From: Andrew Assinder [REDACTED]
Sent: 29 April 2021 14:13
To: Richard Sherman <Richard.Sherman@arun.gov.uk>; Planning <Planning@arun.gov.uk>
Cc: AA Home [REDACTED]
Subject: FP/58/21/HH Planning Application - Comments

Dear Sirs, FAO Arun Planning Department and Mr Richard Sherman

Figure 1

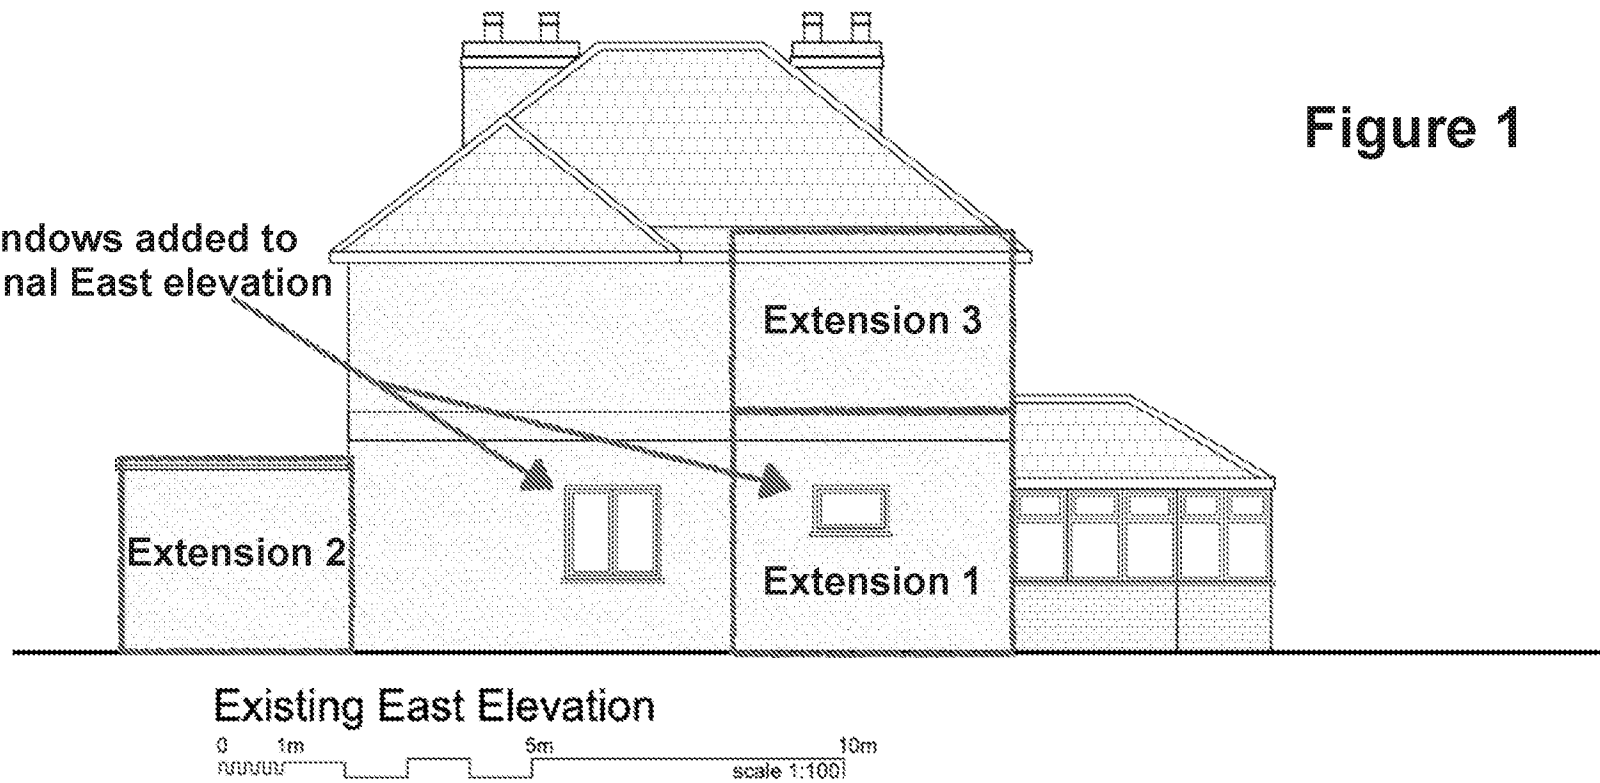
- Since we have owned no 47, there have been three major external extensions of number 45, all on the east elevation facing us. Two ground floor, and one first floor. Please refer to the annotated East Elevation drawing Fig.1. All have impacted on our right to light; the first floor 2010 extension severely so to our kitchen and a bedroom, as did the 1996 garage extension to our kitchen and cloakroom. It should be noted that the 2010 planning approval said no site visit had been needed or made, and that there was no impact on neighbouring houses, which was not true. I was working overseas some of that year and did not see the planning application in time to make any comments;

Windows added to original East elevation

Figure 3

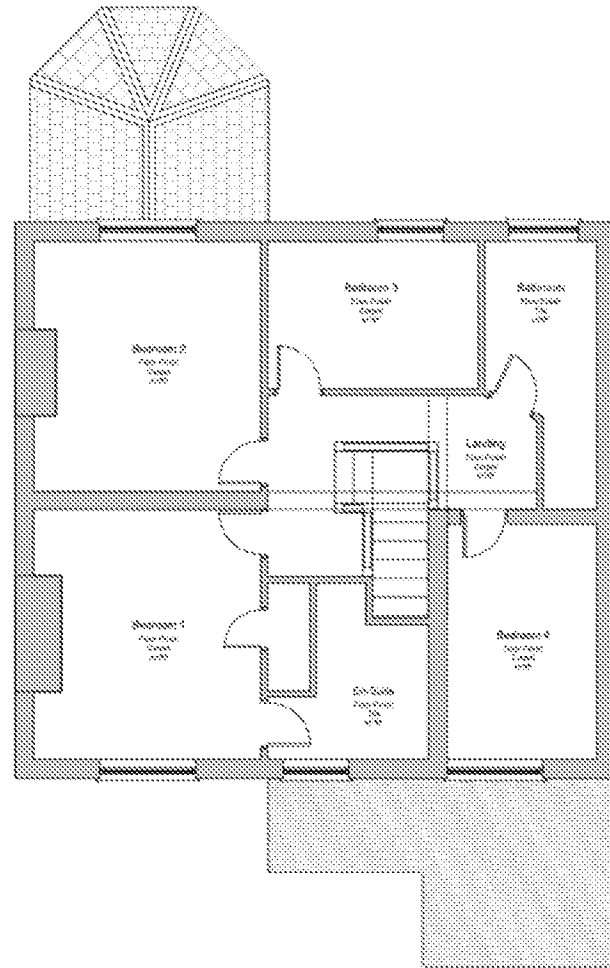
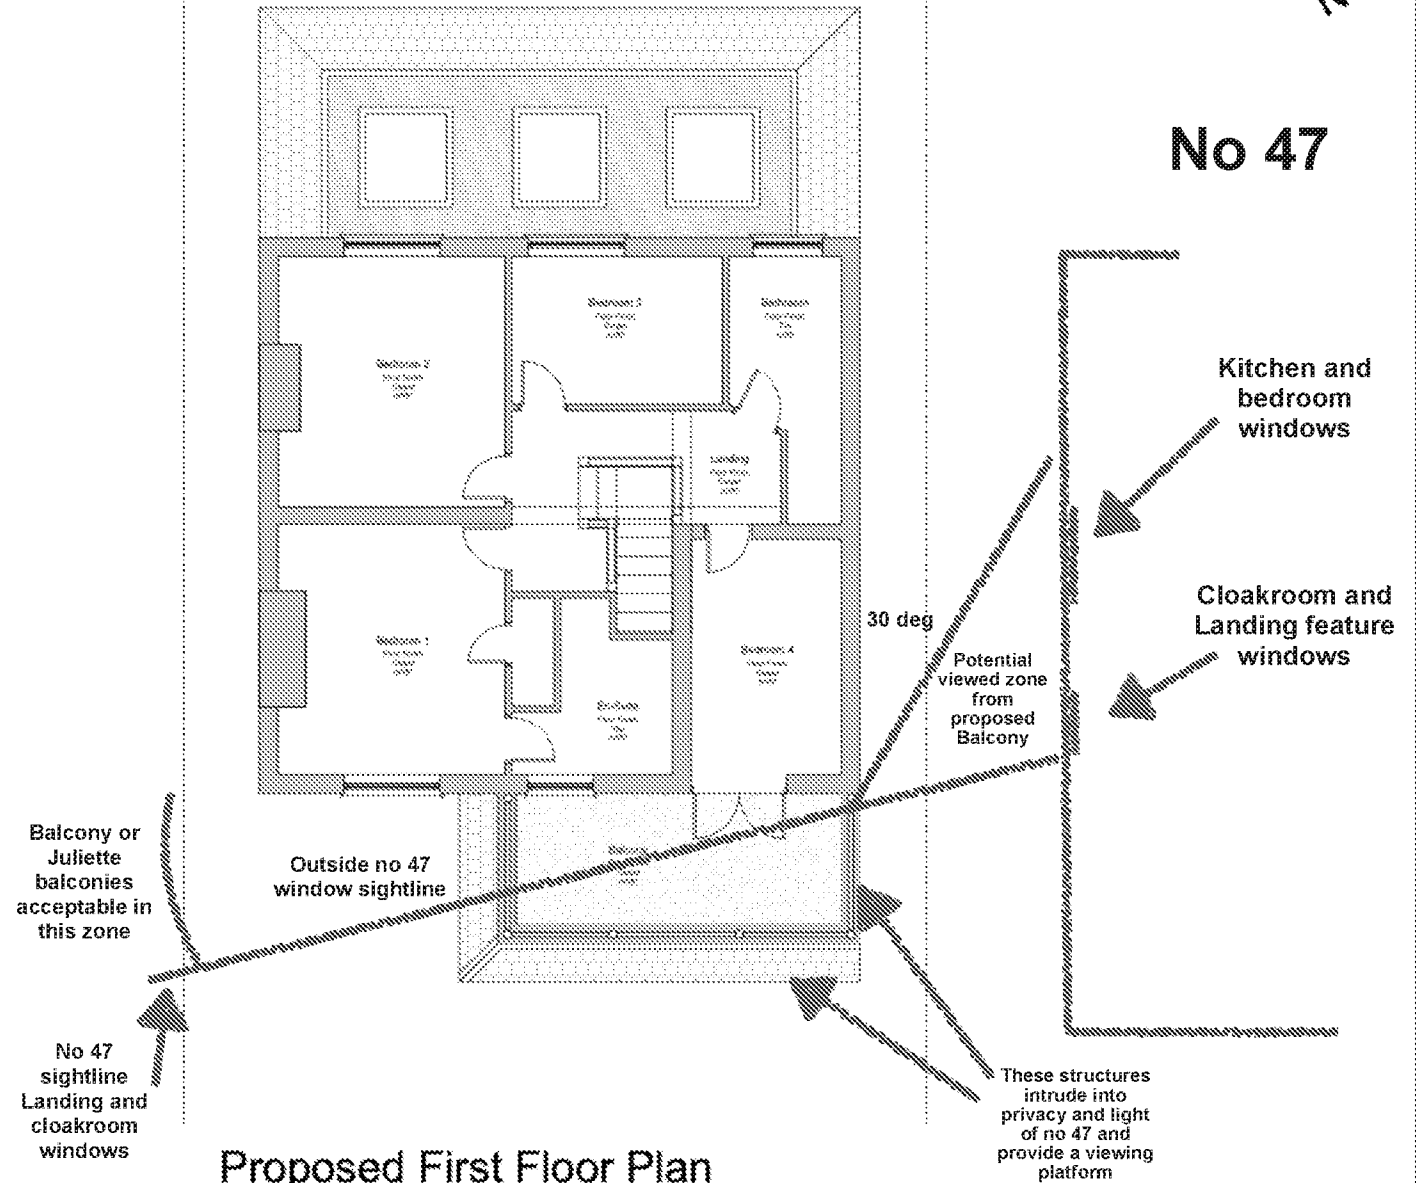
- the proposed front balcony would provide a first floor height viewing platform just over three metres distant towards no 47 spanning from the northeast to southeast directions, giving sight into the kitchen, cloakroom, bedroom and especially the full height landing feature window. These windows are all glazed with clear glass as since the house was built they have never been overlooked. The balcony structure and false roof would block the only remaining skylight into these west facing windows. Please refer to Fig 3 showing the balcony view point and our landing window sightline. It is hoped that the essence of the problem is evident in this figure. The balcony view to the southeast also becomes more intrusive than existing windows into the enclosed front garden, but this is a lesser concern.

- The Drawing 1475-P004, First Floor plans, has omitted the crown tiled roof overhang to the east, which would show that it extends to under 1 m from the east boundary, significantly less than the 1,2m SEMCO policy requirements;

Figure 4

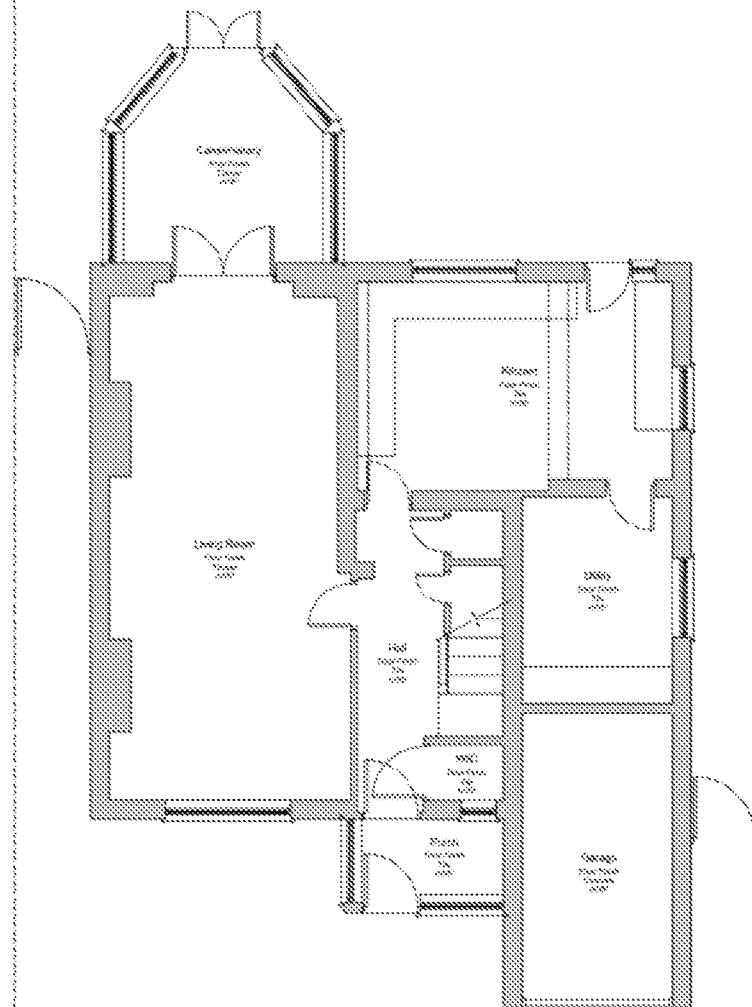
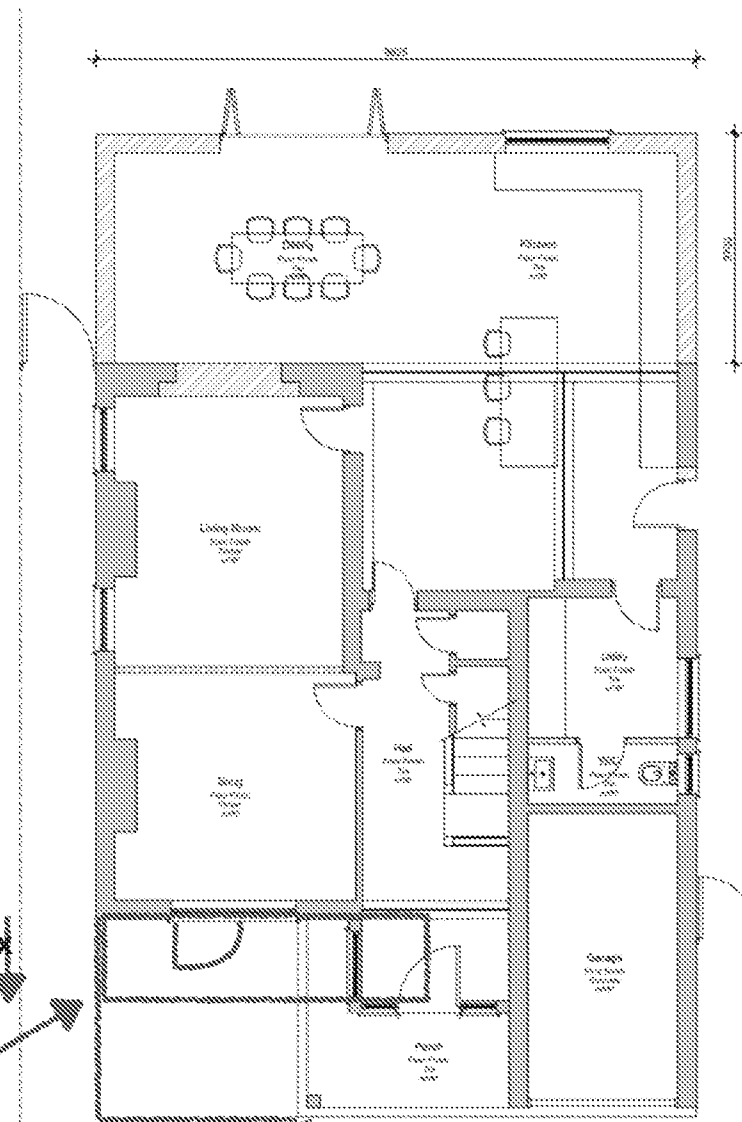
- There are certainly alternative acceptable ways to achieve the facility of a balcony to the front of the house while not encroaching into the sightline from our landing window, and therefore not encroaching on our right to light and privacy, such as Juliette balconies to the front windows, or a more shallow balcony at the western end of the south elevation, either supported by the porch and vertical post(s) or by extending the new porch further west, all behind the sightline as shown on the marked up plan view Fig 4.

Alternative balcony, accessed from Master bedroom, supported by porch and post, or extend the porch westwards for full support and then possible to create access from the Snug

1,8m max

Possible porch with potential for Snug access also

Balcony or
Juliette
balconies
acceptable in
this zone

No 47
sightline
Landing and
cloakroom
windows

Current Landing view with
proposed balcony outline

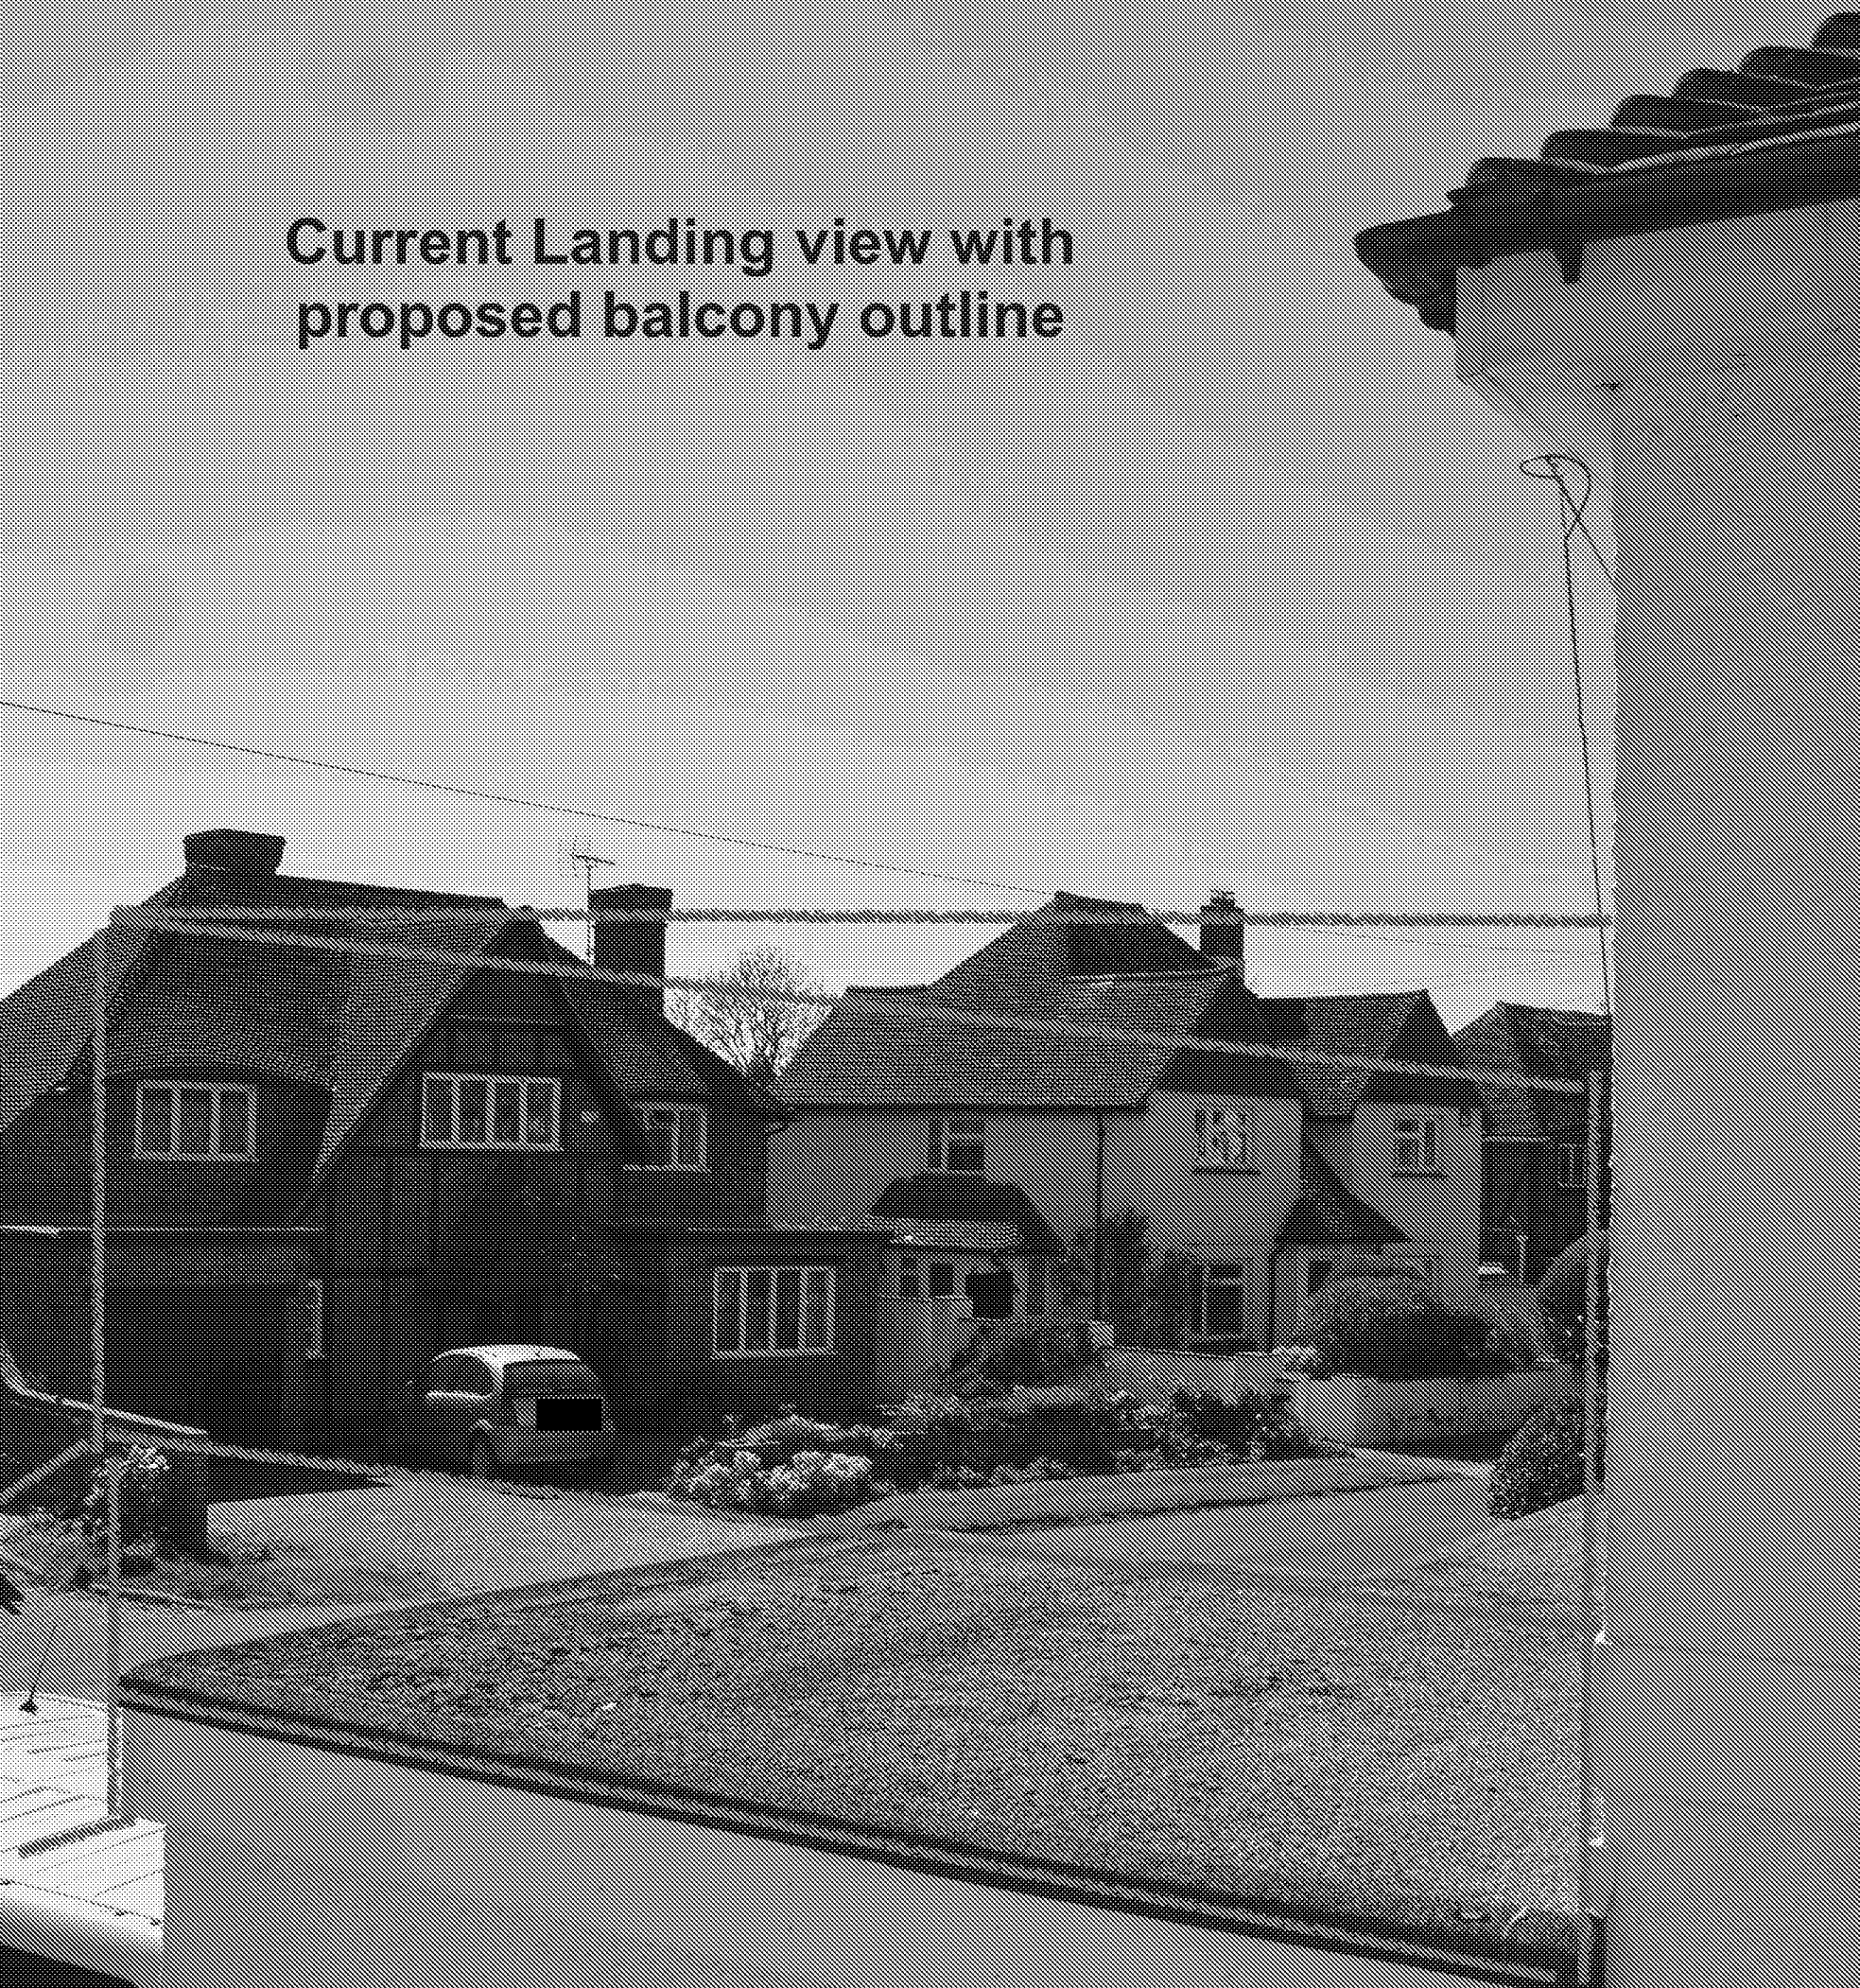
- Several photographs are attached to show the views which would be impacted by the front balcony structure, and we would be more than happy for a site visit to witness the potential issues first hand.

Outline of proposed
balcony seen from
cloakroom

Figure 5

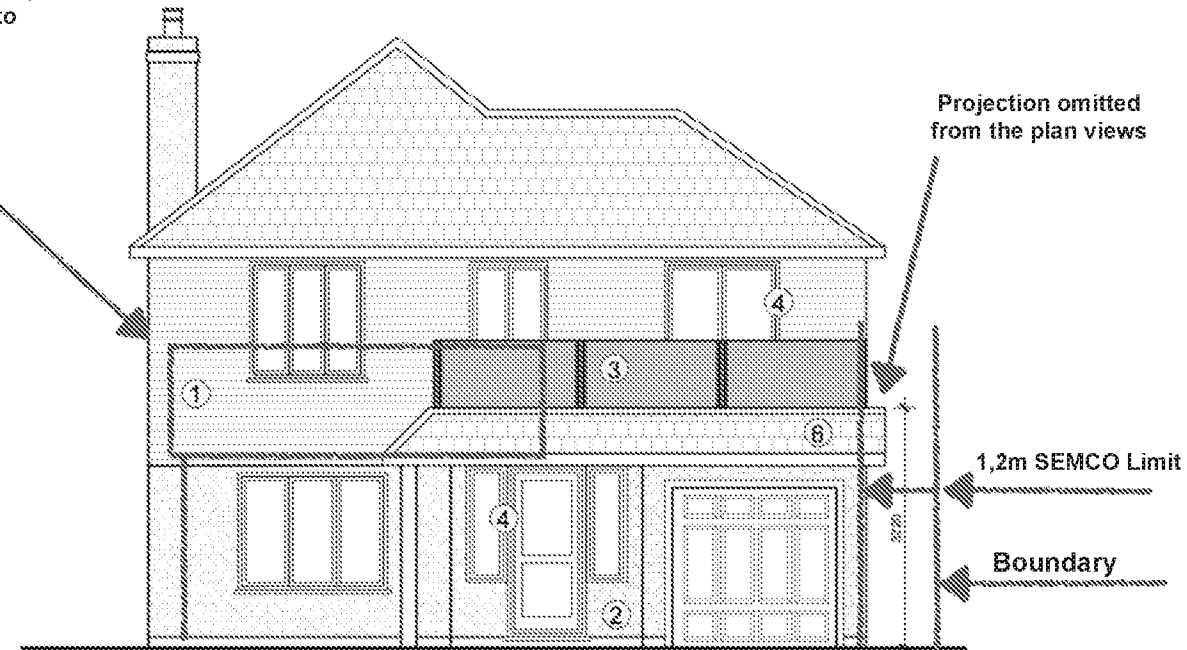
- A major benefit of Juliette balconies or a western balcony is that it would then engage with the Master bedroom, not the second bedroom as proposed. See Fig 5

Alternative balcony accessed from Master bedroom, projecting maximum 1,8m possibly forming canopy outside the Snug or above the porch extended to the West building edge, with access from the Snug. Obscuring glass only necessary to west, no invasion of privacy/right of light to number 47
